Car Stereo
Service Bulletin

Model: RM-X2

No. 255

Subject: Part Number Change: PC Boards

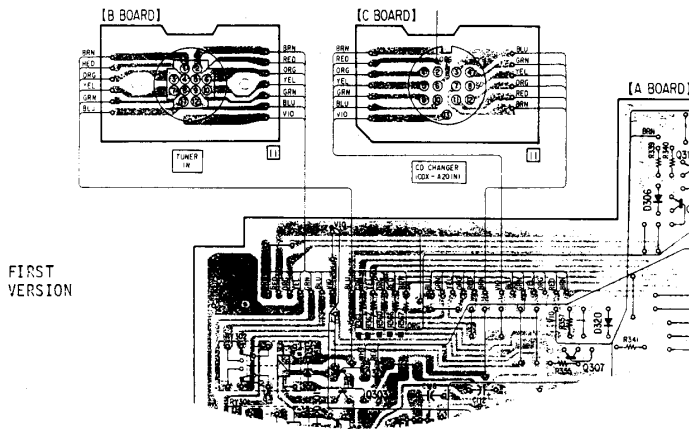
There is a difference between the B and C connector wiring on the first version Main PC Board and revisions 2 and 3 of the Main PC Board.

This makes it necessary to rewire the B and C connectors when changing the Main PC Board.

If it is necessary to replace any of the PC Boards, replace them simultaneously with the part numbers shown below:

REFERENCE	DESCRIPTION	PART NUMBER	
		FORMER	NEW
907	MOUNTED PCB, A	A-3279-729-A	A-3279-739-A
908	PC BOARD, C	1-625-385-11	1-626-958-11
909	PC BOARD, B	1-625-386-11	1-626-957-11
